APPEAL # 6

2021-2274-ZC

ZONING STAFF REPORT

REQUESTED CHANGE: From PBC-1 Planned Business Campus and A-4 Single-Family Residential District to PBC-1 Planned Business Campus, A-4 Single-Family Residential District, and PUD Planned Unit Development District

P.U.D. CONCEPTUAL PLAN AND TENTATIVE SUBDIVISION PLAN
VIEWX CARRE
SECTION 46, T-7-S, R-11-E
ST. TAMMANY PARISH, LA.

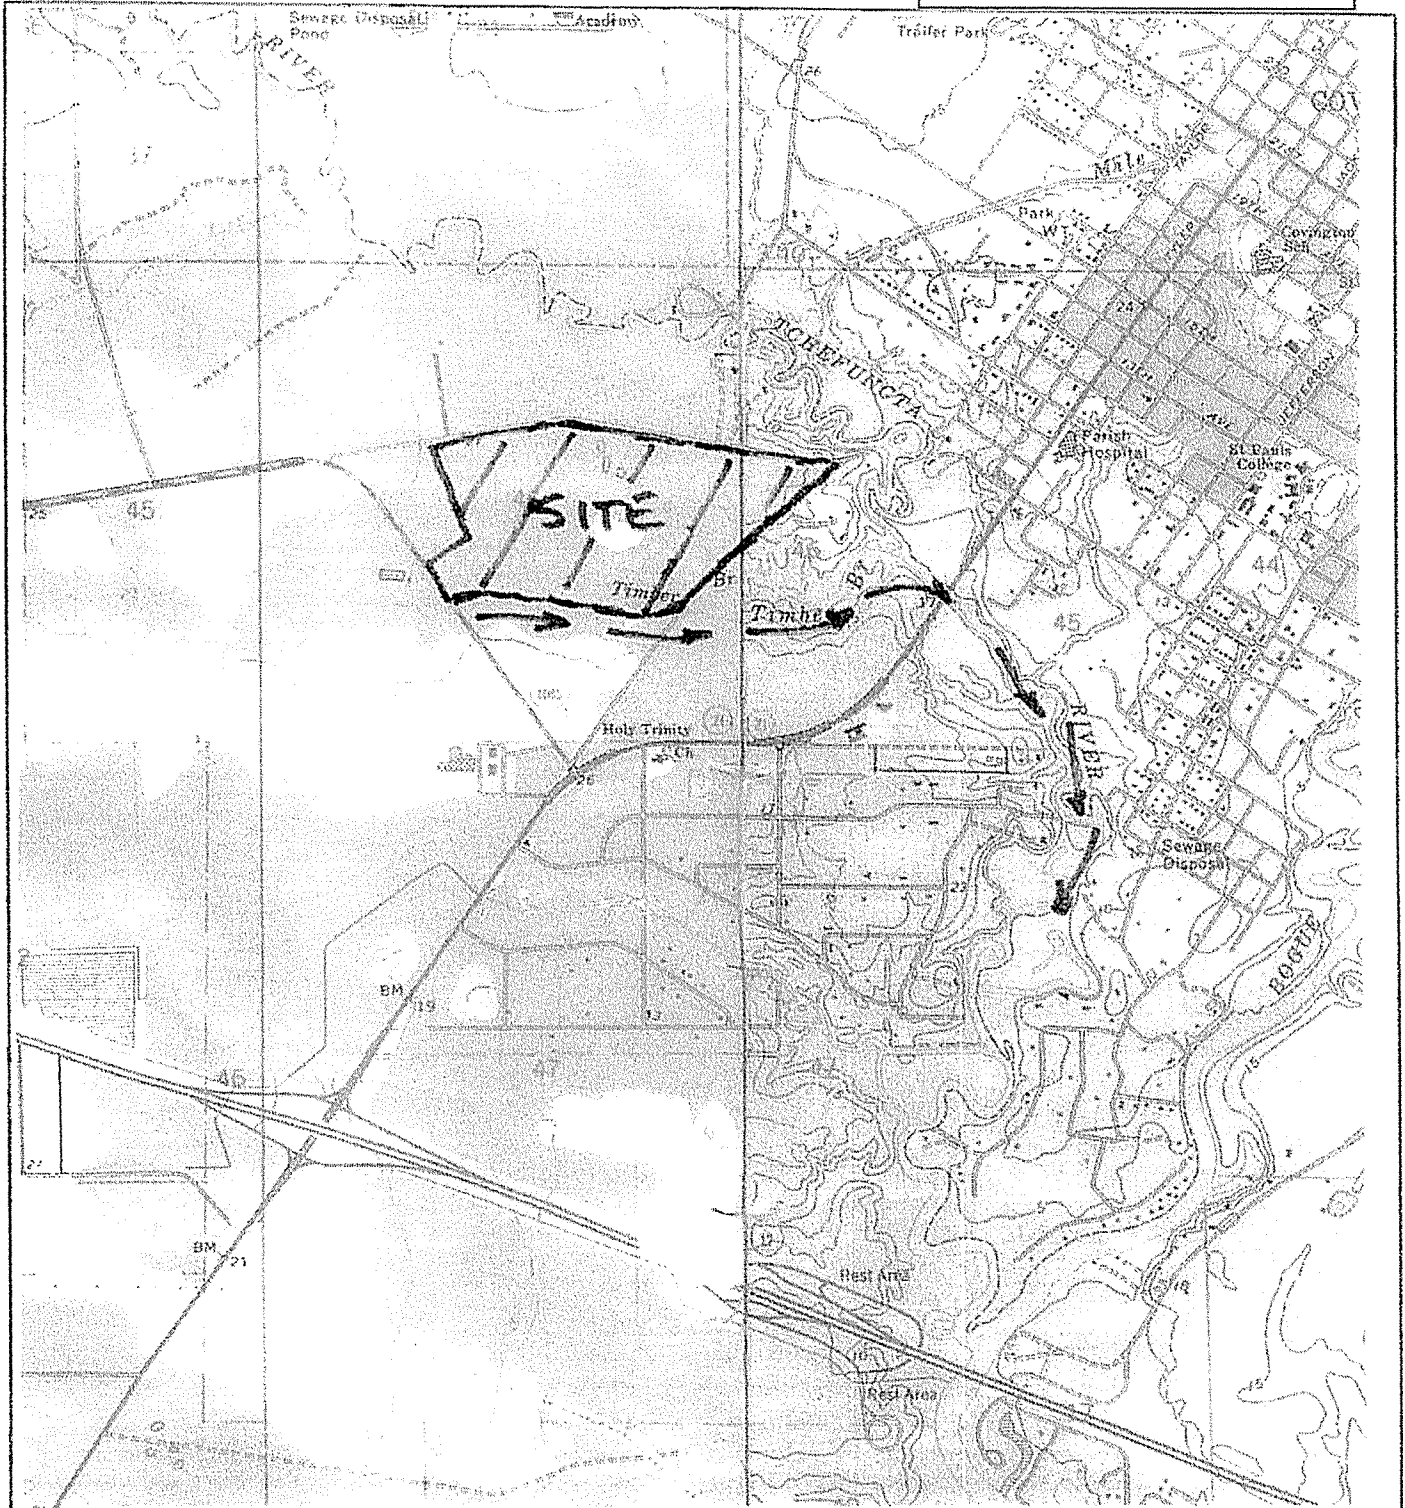
- The proposed PUD plan is providing 335 standard lots which are dimensioned at 60 ft. x 120 ft. and 80 garden home lots which are dimensioned at 50 ft. x 100 ft. – 120 ft. As submitted, there is no diversification of single-family housing types. The 14.87 acre “Planned Business Use Area” provides a mix of uses.

- The developer should consider alternative construction types of home sites. This could provide a variation in residential development as well as minimize conflict with existing wetlands on site.

3. *Functional and beneficial uses of open space areas.*
 - The proposed PUD plan has allocated 10.66 acres of undeveloped greenspace to act as water access to Timber Branch. This access has no formal entry point and residents looking to use this recreational area will need to first traverse the 16.96-acre dry detention storage area. Staff recommends establishing a formal entry point for residents to actively use the space as well as the creation of a potential permeable parking area.

- The active recreational space that is proposed along the south side of the property includes nature trails. These trails appear to run in an east-west manner, in-between the dry stormwater area and the area dedicated to water access for the residents. These trails do not connect to the servitude which acts as the only formal access to these greenspaces and abruptly end at the edge of the site plan. The petitioners should reorient these walking paths to be inclusive of the entire useable portions of the greenspace as well as to provide access from the residential areas to Timber Branch.

- The natural greenspace areas located along the southern perimeter of the proposed PUD should be placed into a conservation easement. This easement would permanently limit the use of the land and ensure the public benefit of open space is maintained.

5. *Creation of a safe and desirable living environment for residential areas characterized by a unified building and site development program.*
 - The proposed PUD plan should provide a formal access and extend the walking trail from the residential area to the greenspace which is provided along the south side of the plan. This addition will help to create a unified building and site development program.

- The proposed traffic circulation consists of one collector type road known as Armstrong Parkway which will service 263 home sites along the north side of the development and 152 home sites along the south side of the development. The road is bordered on either side with a 50 ft. buffer which will help to alleviate noise and increase safety to the abutting homesites. Staff recommends the applicant mimic the boulevard type entryway which is shown at the intersection of Bootlegger Road and Armstrong Parkway along the intersection of Bricker Road and Armstrong Parkway.

- The current configuration shows the proposed commercial area having access along Armstrong Parkway, which is the main roadway which provides access for the 415 proposed residential dwellings. As the permitted uses for the commercial area appear to provide uses consistent with large-scale office development, the applicant should increase the buffer in-between the commercially zoned portion of the PUD and the residential uses. Staff recommends the applicant ensure additional stress on current traffic situations are mitigated.

Staff has noted several examples which could create problematic features upon reviewing the PUD Plan. Examples of these potential issues include the following:

1. Staff has concerns with the percentage of wetlands that exist within the subject property. Staff recommends the applicant work with their engineering team to ensure that if the wetlands are programed to be developed, they are done so in an environmentally friendly design including limiting land disturbance, protection of natural areas and habitats, and innovative and effective stormwater management.

- ~~2. Staff has concerns with the water levels along the north-south portion of Bricker Road during storm events, where it intersects with the proposed Armstrong Parkway. Staff recommends the applicant work with their engineer to construct a bridge along this portion of Bricker Road to ensure the safety and feasibility of new traffic to the area.~~

3. Staff is concerned with the increase in density that the requested zoning classifications would allow. The property is developable with the existing zoning classifications and a lesser allowable density.
4. Based on data sets provided by the Trip Generation Manual, 10th Edition Supplement, it appears that the proposed density of this development will generate over 5,000 new vehicle trips a day to the area.

5. The PUD plan provides little to no housing type diversification offering only 50'x100' and 60'x120' lot types.

The developer and his engineer agree that the low portion of Bricker Road where Timber Branch crosses it needs to be evaluated and improved as part of this project. The evaluation of this crossing will require additional modeling to accurately determine the correct improvements and elevations for the roadway and crossing in this location. This will be required as part of the developer's submittal for Preliminary Subdivision Approval.
